SEWAGE DISPOSAL SYSTEM

MARYLAND STATE DEPARTMENT OF HEALTH

SUBDIVISION Moorefield ROAD Cherry Tree Drive LOT 8 - A

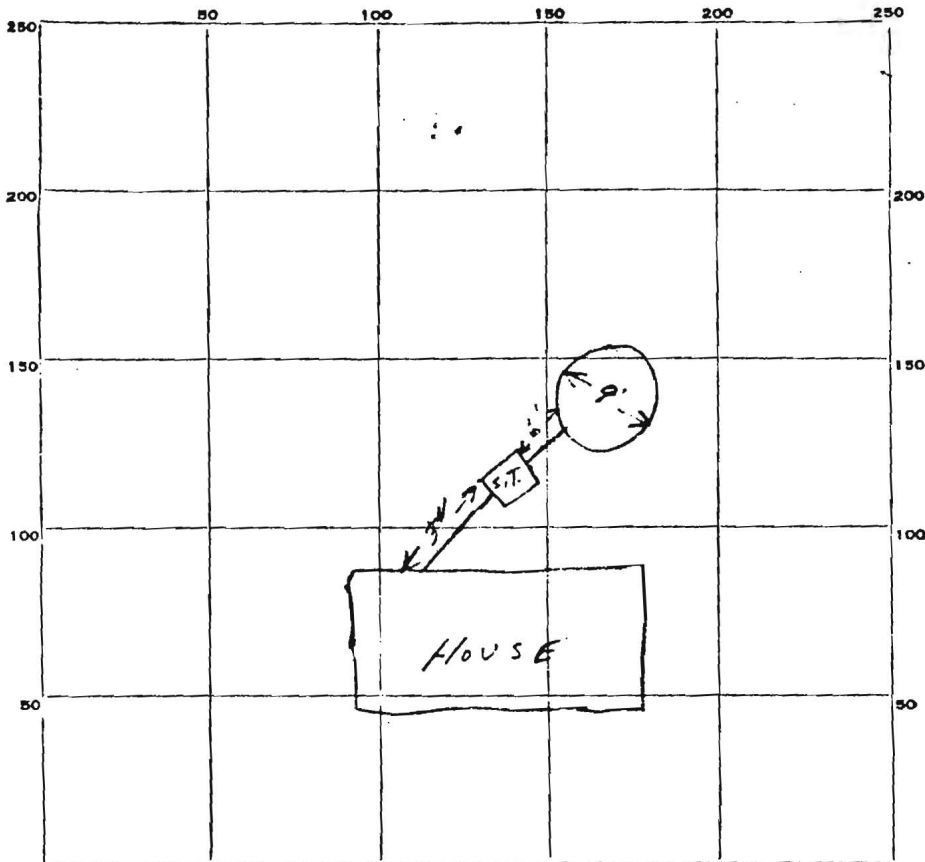
*Incomplete
7/30/64*

*installed
not not
approved due to
cleanout being needed
on Septic Tank*

REMARKS 7/29/64 System needs an 8" clean out pipe installed on septic tank
